# D Block - Ground floor

Client  
 DEBACATING SOCIETY TRUST OF SRI LANKA  
 UNIVERSITY GRANTS COMMISSION

Drawing Title  
 AS BUILT DRAWING OF  
 IT ARRANGEMENT  
 BASEMENT FLOOR

Drawing Title:  
**AS BUILT DRAWING OF  
IT ARRANGEMENT  
UPPER FLOOR**

**Block - ground floor**

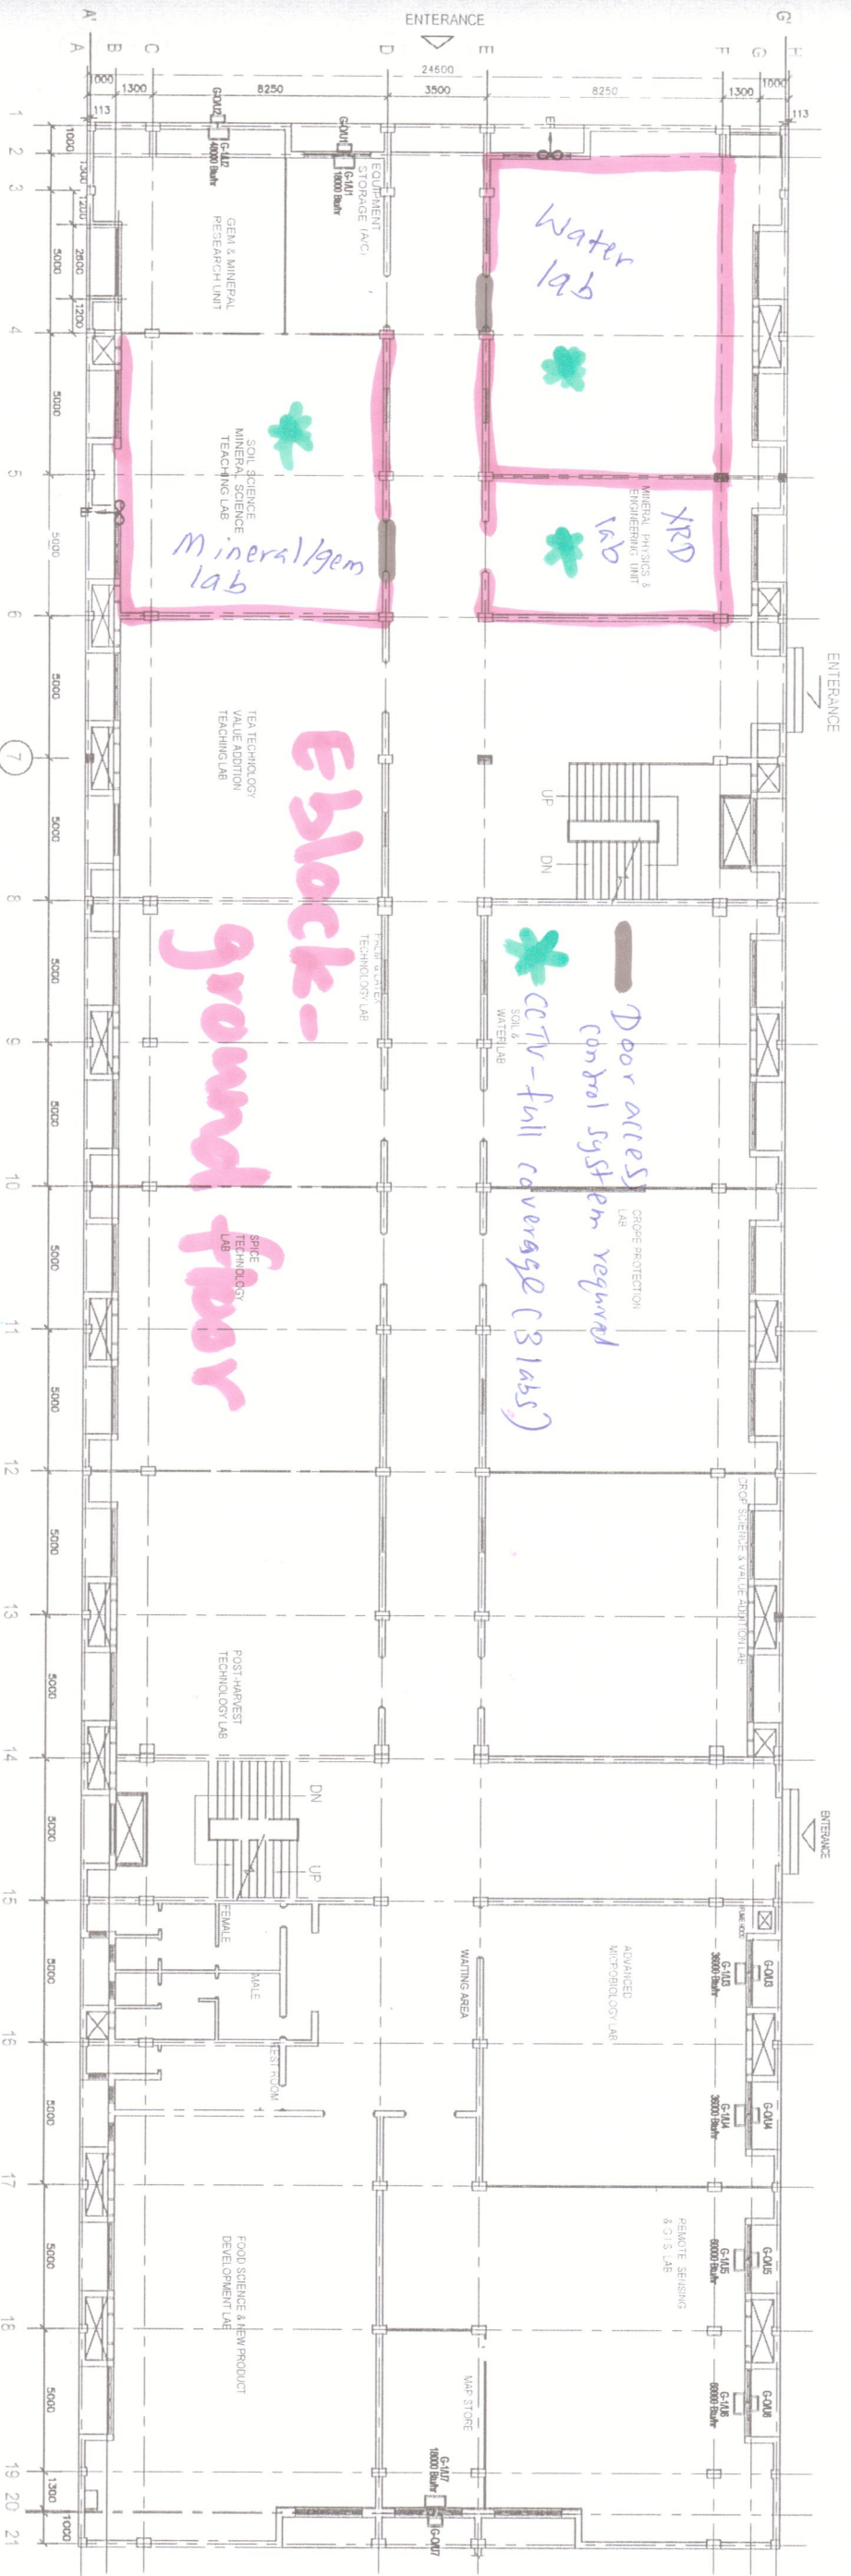
Door access control system required  
CCTV - full coverage (81455)
